Access Compliance Report

Public Rights-of-Way (Curb Ramps)

Intersection ID: 53963	Main Street: MAGNOLIA_LILY_AV	Cross Street: LILAC_TREE_AV	Location: NW
ADA ID: B457C1D5BCE2	Ramp Type: Perp	Initial Pass/Fail: Pass	Overall Compliance: No
		Severity Score: 15

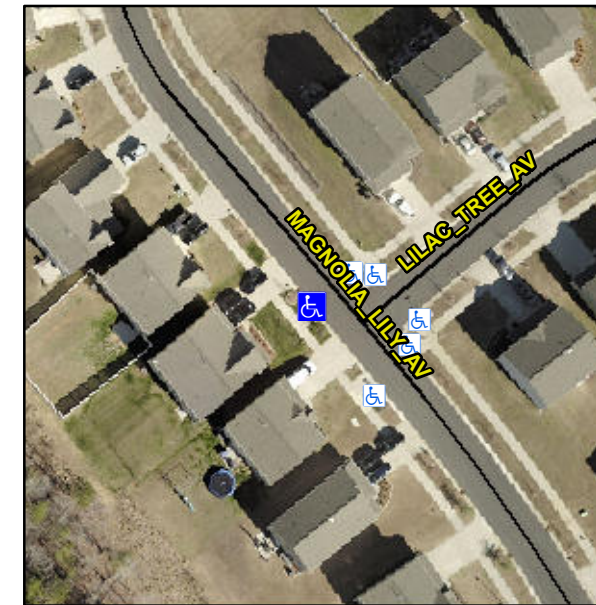
Not Found, R304.5.3, R305.2, R302.7.2

Compliance	Description	Data	Compliance	Description	Data
N/A	Ramp Length (in)	95.0	Yes	Ramp Slope (%)	6.0
Yes	Ramp Width (in)	48.0	Yes	Ramp XSlope (%)	1.8
N/A	Flare Type LT	Sloped	N/A	Flare Type RT	N/A
N/A	Flare Slope LT (%)	3.0	N/A	Flare Slope RT (%)	8.5
N/A	Flare Traversable LT?	No	N/A	Flare Traversable RT?	No
Yes	Landing Length (in)	59.0	Yes	DWS Provided?	Yes
Yes	Landing Width (in)	104.0	Yes	DWS Contrast?	Yes
Yes	Landing Slope (%)	1.5	Yes	DWS Length (in)	24.0
No	Landing X Slope (%)	3.5	Yes	DWS Full Width?	Yes
N/A	Landing Curb? (Y/N)	No	No	DWS Offset (in)	4.0
N/A	Shared Landing?	No			
Yes	Gutter Ponding?	No	Yes	Gutter Slope (%)	1.2
No	Gutter Lip Ht (in)	1.3	Yes	Gutter X Slope (%)	1.5
N/A	Painted X Walk1?	No	N/A	Painted X Walk2?	N/A
	X Walk 1 Direction	To E		X Walk 2 Direction	N/A
N/A	X Walk 1 Width (in)	N/A	N/A	X Walk 2 Width (in)	N/A
	X Walk 1 Slope (%)	4.3		X Walk 2 Slope (%)	N/A
	X Walk 1 X Slope (%)	2.0		X Walk 2 X Slope (%)	N/A

Remove & Replace Entire Ramp.
